UNITED STATES PATENT AND TRADEMARK OFFICE

APPLICATION NO.	FILING DATE	FIRST NAMED INVENTOR	ATTORNEY DOCKET NO.	CONFIRMATION NO.
10/632,028	07/31/2003	Andrew J. Ries	P9173.00	9663
27581	7590	06/27/2006	EXAMINER	
MEDTRONIC, INC. 710 MEDTRONIC PARK MINNEAPOLIS, MN 55432-9924				ALTER, ALYSSA M
		ART UNIT		PAPER NUMBER
		3762

DETAILED ACTION

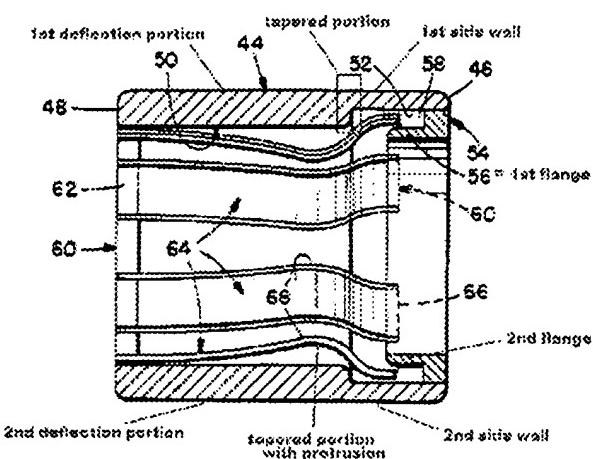
As seen in figure 5, "a leaf spring member 60 includes a base element 62 fixed to the first cylindrical passage adjacent the distal end 48 of the barrel 44 and a plurality of integral resilient spring elements 64 extending from the base element at a plurality of

circumferentially spaced locations to tip ends 66 freely received in the annular recess 58 for limited transverse movement between the second cylindrical passage 52 and the annular flange 56. The leaf spring elements 64 have contact portions 68 intermediate the base element 62 and the tip ends 66 which project and are biased toward the longitudinal axis of the barrel for mating engagement with a proximal end of the electrical lead 22, specifically with the second contact 32 when inserted into the barrel from the distal end 48 and generally aligned with the longitudinal axis of the barrel. Preferably, the resilient spring elements 64 extend from the base element 62 at a plurality of equally spaced circumferential locations to maximize uniformity of contact force between the spring elements and the second contact 32 of the electrical lead 22"(col. 5, lines 33-52).

As to claims 1 and 16, the examiner considers one of the six arms to be a first and another one of the arms to be the second. The two arms are also connected at the top of the clip. Also, the first position is prior to the insertion of the spring into the housing, the second position is prior to the insertion of the lead and the third position is after the insertion of the lead.

As to claim 7-15 and 22-30, the figure to the right has been included to depict the corresponding portions of Hawkins to the components of recited claims 7-15 and 22-30. Depicted in the replication of Hawkins figure 5. In addition, the 1st and 2nd flange can also act as a tapered deflection portion.
